**Distribution of Textron Lycoming  
Service Bulletin 529A, "Reprint of  
Crane/Lear Romec Service Bulletin No.  
101SB020, Rev.2"**

Service Bulletin No. 529A  
 (Supersedes Service Bulletin No. 529)  
 Engineering Aspects are  
 FAA Approved

SUBJECT: Reprint of Crane/Lear Romec Service Bulletin No. 101SB020, Rev. 2

## FUEL PUMP – Torquing of Relief Valve Cover Screws.

Torquing Sequence – RG17980 Series  
Figure 1

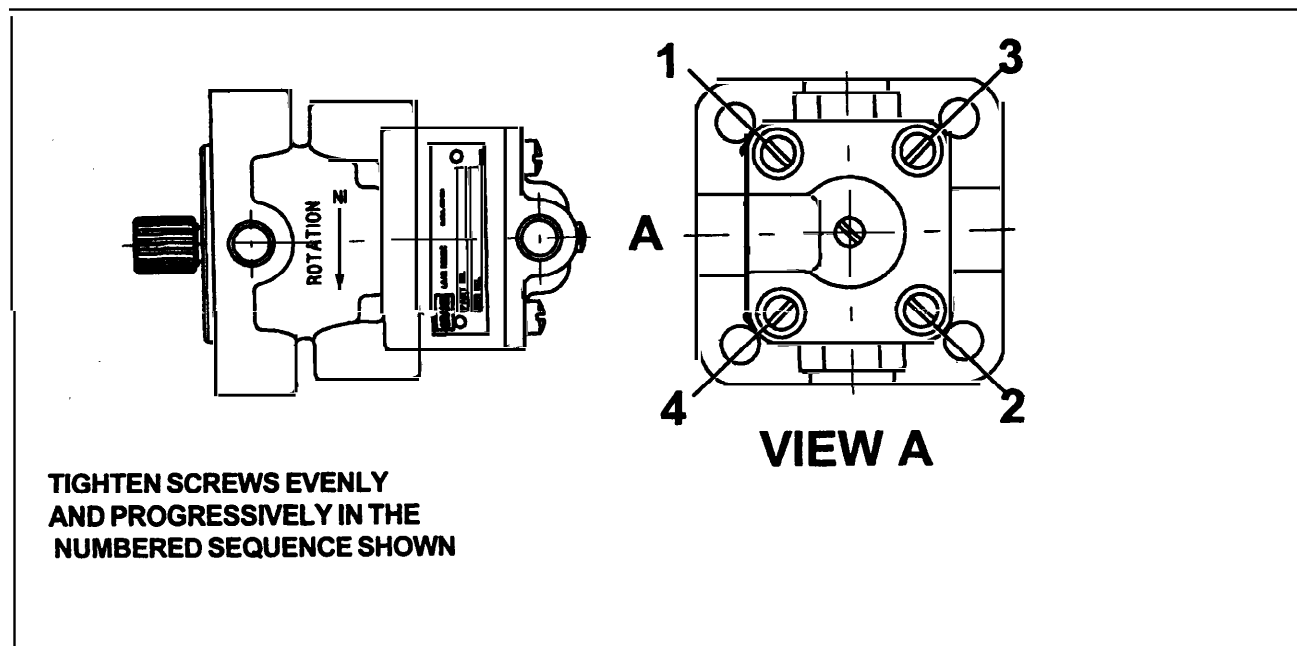
- (a) If pump is accessible without removing it from aircraft, the following check shall be performed.
- (b) Visually inspect the split line between the pump housing and relief valve housing for any evidence of noticeable gasket extrusion adjacent to the pump inlet & outlet ports. If there is evidence of noticeable extrusion, replace the pump per applicable engine maintenance instructions.
- (c) Check the tightness of relief valve cap attaching screws using a torque indicating screwdriver. Minimum torque shall be 23 inch-pounds. Torque shall be checked in the tightening direction.
- (d) If screws are loose, remove safety-wire and tighten screws evenly and progressively in a criss cross pattern to 23-25 inch-pounds torque in the sequence shown in figures 1 and 2.

- (a) Visually inspect the split line between the pump housing and relief valve housing for any evidence of noticeable gasket extrusion adjacent to the pump inlet & outlet ports. If there is evidence of noticeable extrusion, replace the pump per applicable engine maintenance instructions.
- (b) Check the tightness of relief valve cap attaching screws using a torque indicating screwdriver. Minimum torque shall be 23 inch-pounds. Torque shall be checked in the tightening direction.
- (c) If screws are loose, tighten screws evenly and progressively in a criss cross pattern to 23-25 inch-pounds torque in the sequence shown in figure 1 and 2.

**NOTE:** If screw torque registers greater than 23-25 inch-pounds when inspected per para. 2.A.(1)(c) above, the screws need not be backed off and retorqued. This bulletin applies only if screws exhibit preload torque of less than 23 inch-pounds.
